**RE: Aspire Subdivision Unit 3 - 4
Amendment to Drainage Report
Engineer's Stamp Date: 02/09/24
Hydrology File: N08D006F**

Project Title: Aspire Subdivision, Units 1-4 Hydrology File # N08D006F

AMENDMENT TO DRAINAGE REPORT

ASPIRE SUBDIVISION UNITS 3 & 4

Plan View

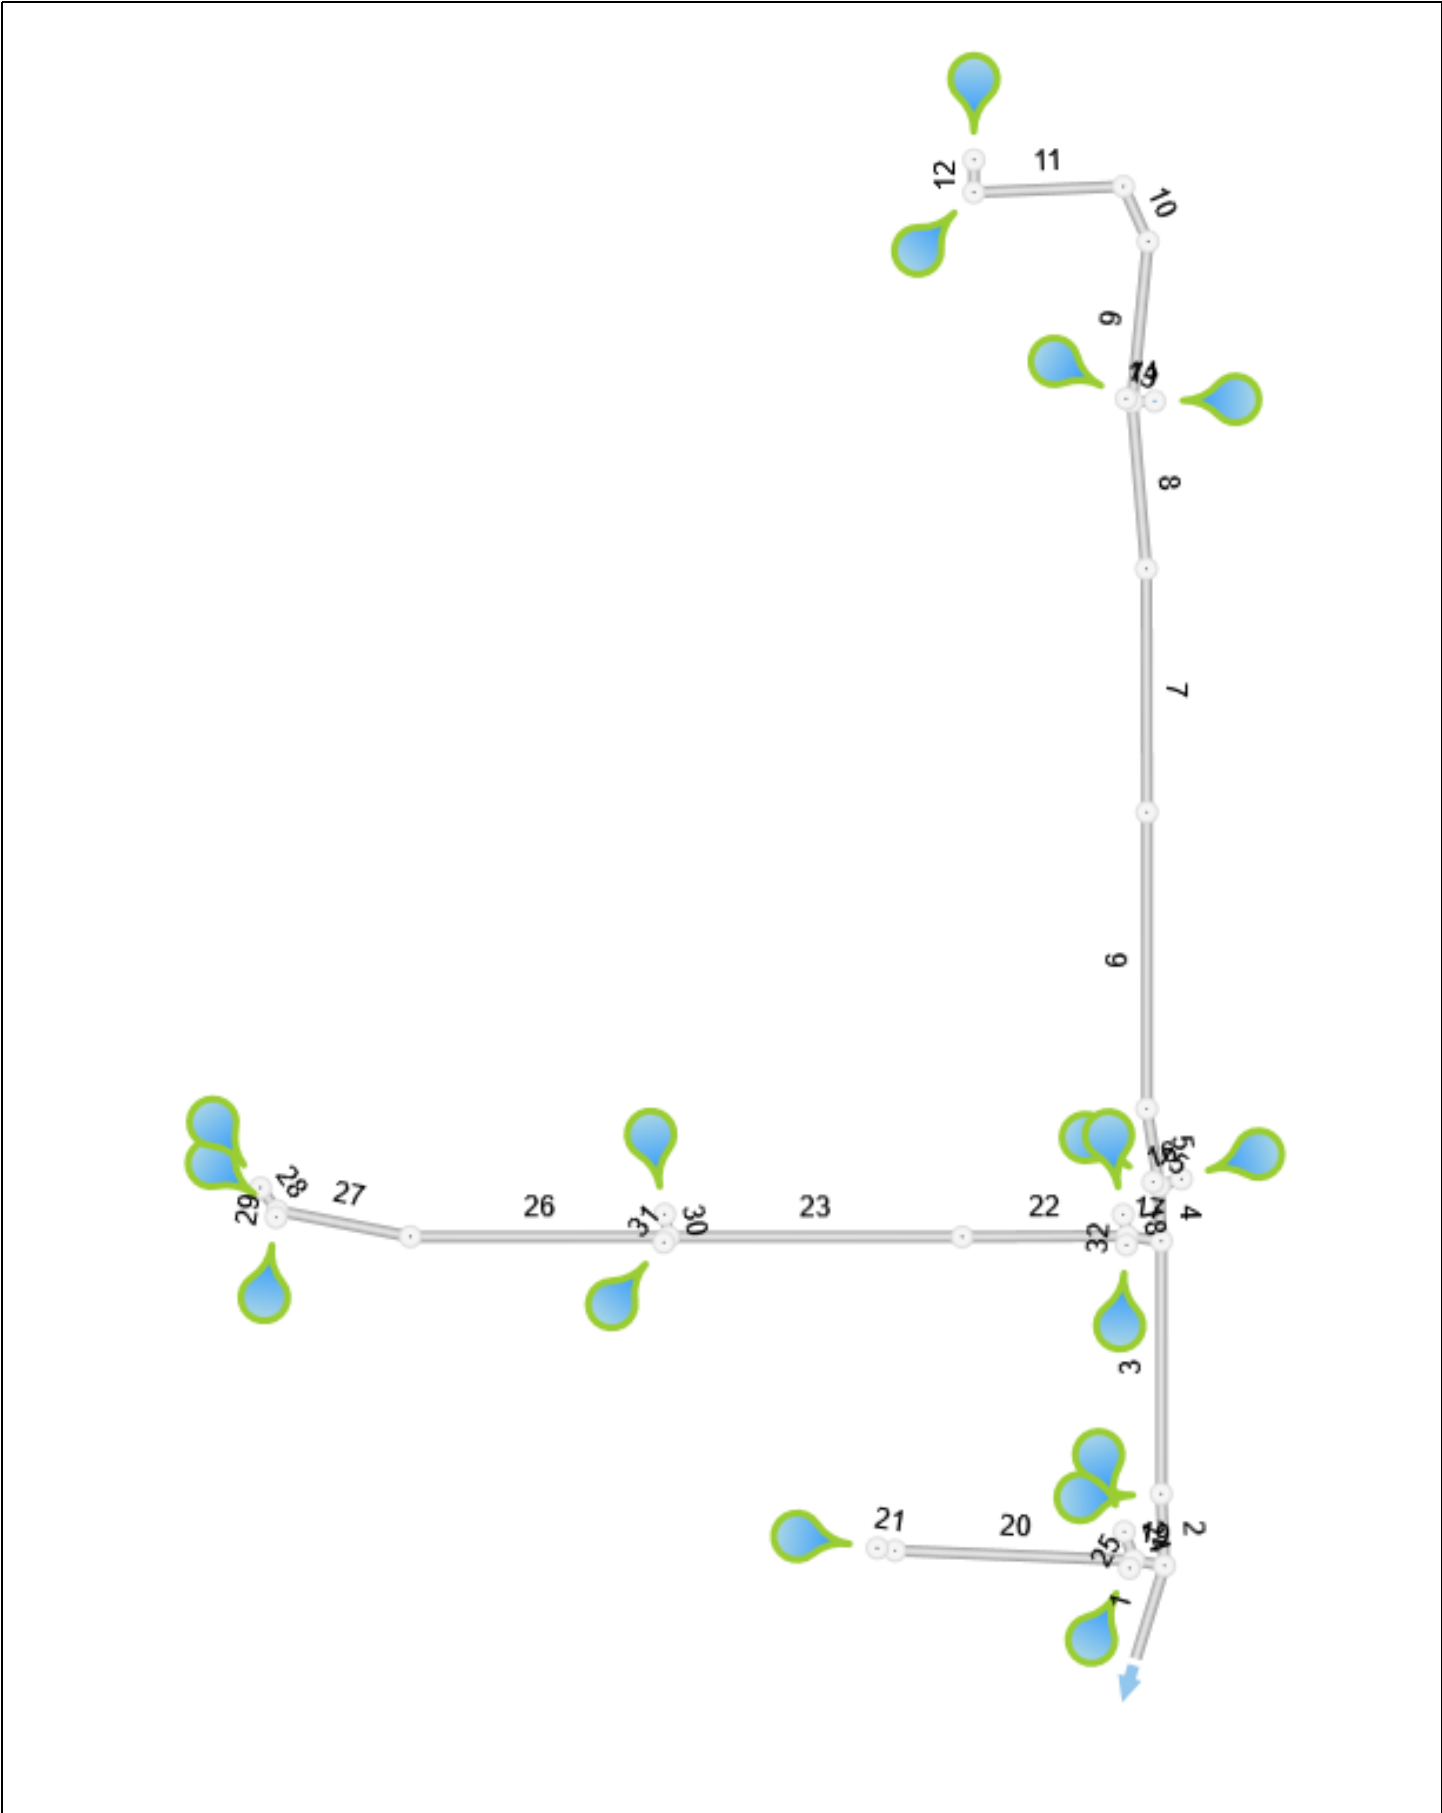
This amendment to the existing Aspire Subdivision Drainage Report eliminates the storm drain outfall at Crestone Way, and redirects that storm drain to continue down Caresso Loop to connect with the proposed storm drain in Cantara Lane.

Field investigations have shown that the existing storm manhole SD MH-29 in Colobel has a 72" stub to the north. This is large enough to allow all the Unit 3 & 4 flows along with a small amount from previous units to discharge to that location.

With this change storm water will enter the existing storm drain in Colobel Ave farther downstream. In the previous design some of that existing pipe was replaced with larger pipes. This change allows the existing pipe to remain the same size.

To account for the increased flow entering the Cantarra Lane storm drain the pipe will be increased to 66" and 72" diameter.

CITY OF ALBUQUERQUE
PUBLIC WORKS DEPARTMENT
ENGINEERING DEVELOPMENT GROUP
ASPIRE SUBDIVISION, UNIT 3
**OFFSITE STORM DRAIN
PLAN & PROFILE**

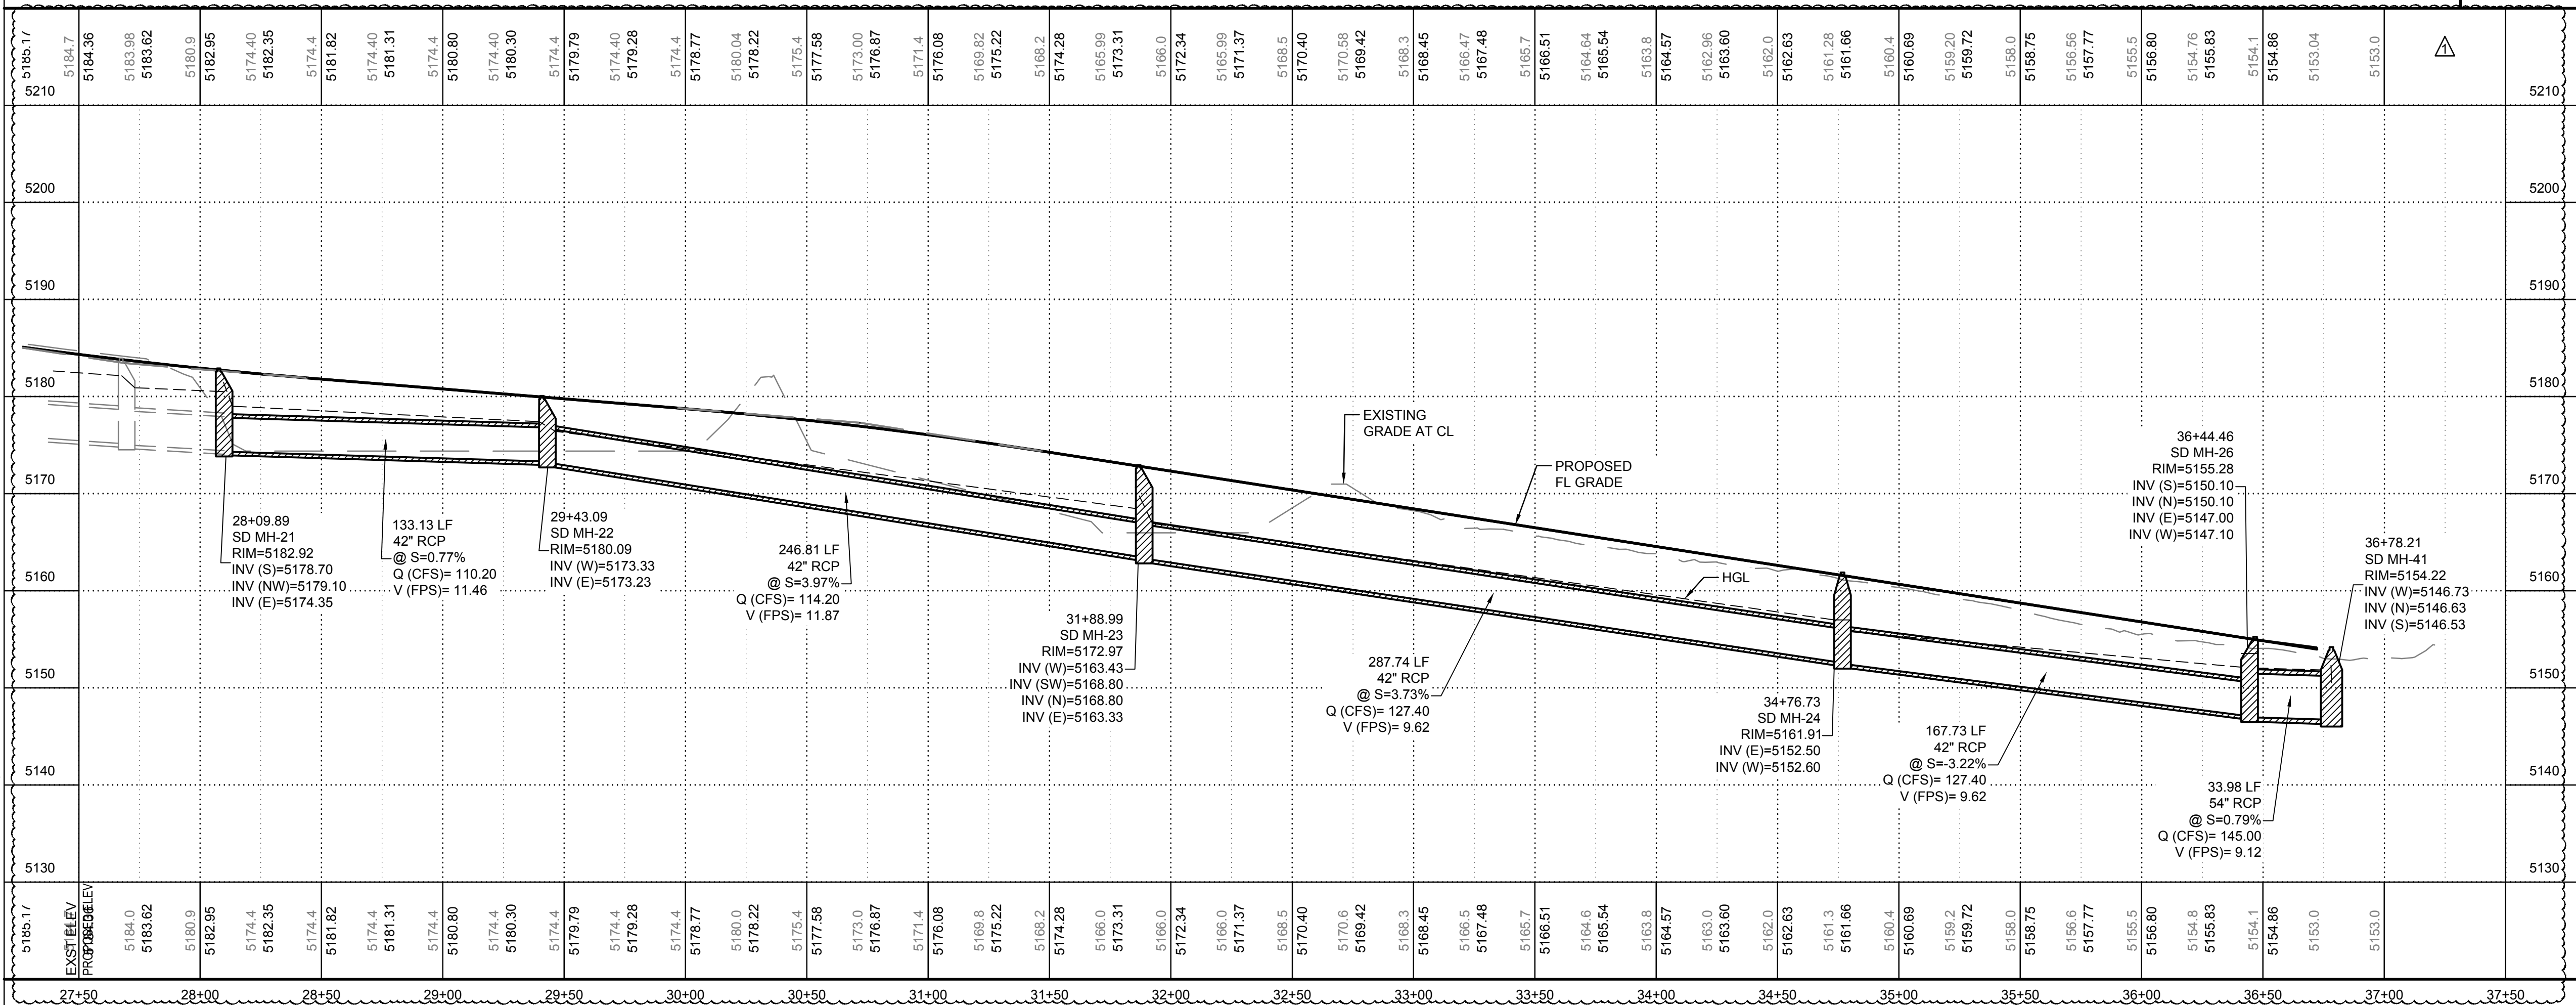
CONTRACTOR TO FIELD VERIFY THE EXISTING 72" STUB INVERT AND SLOPE AT MANHOLE. IF STUB LOCATION AND SLOPE MATCH PROPOSED, PIPE SHALL REMAIN TO INLET 59.
